ANN ARBOR HISTORIC DISTRICT COMMISSION

Staff Report

ADDRESS: 815 W Jefferson Street, Application Number HDC15-210

APPLICATION: The applicant seeks HDC approval to demolish a two-car garage and construct a new garage of the same size, massing, footprint, openings, and materials in its place.

North Elevation
A-2

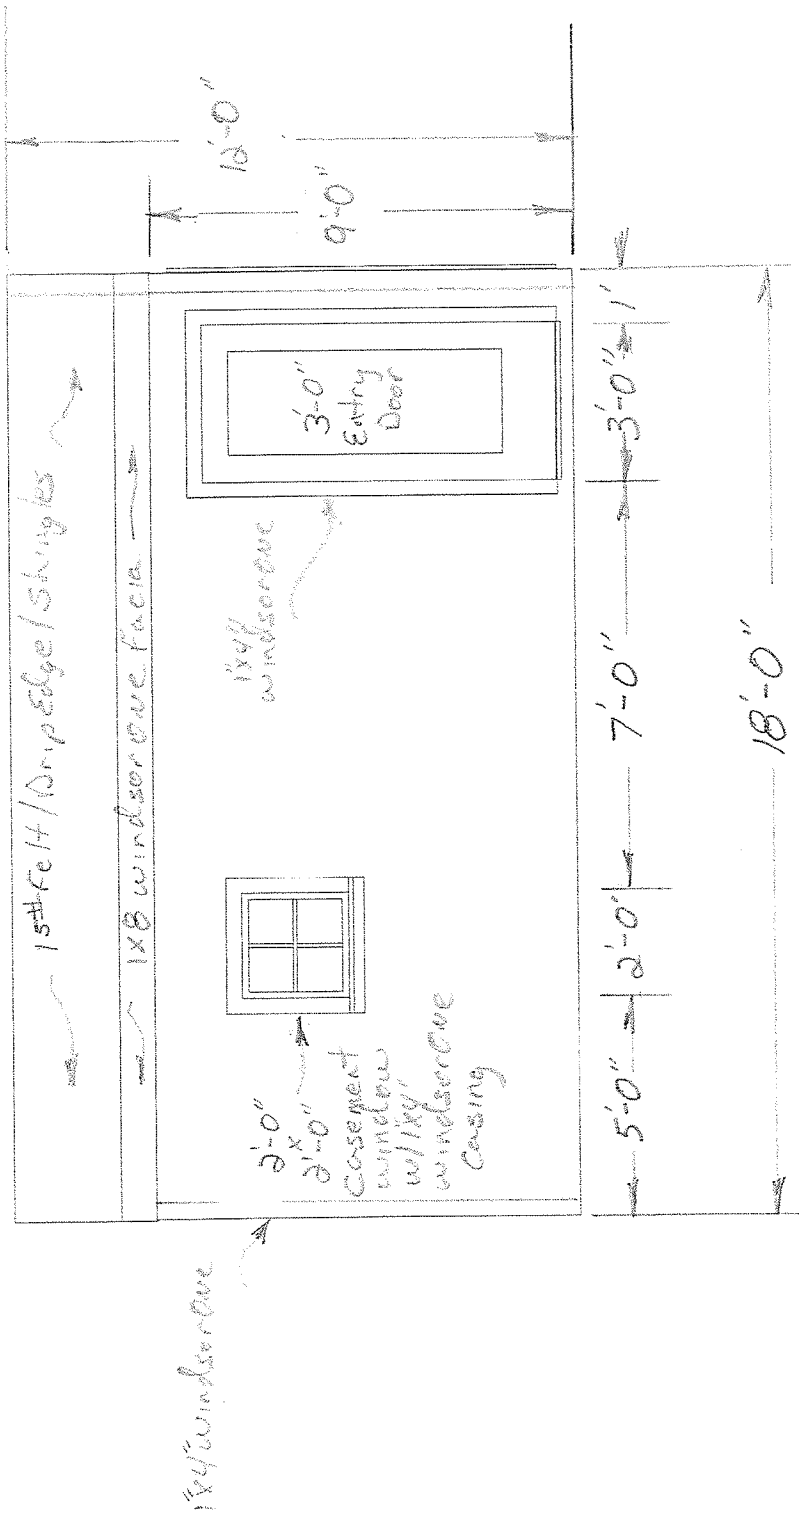
4. The roof is too flat and needs to be pitched, and the new front parapet is less of a departure from the existing appearance than seeing a gable roof on the front of the building.

2. I would like to put a 3/12 gable roof on to eliminate the flat roof. Flat roofs are not very ideal with the environment we live in (heavy snow and rain). To keep the garage looking like the original I propose to build a false front to cover the front gable end (see drawing A-2).
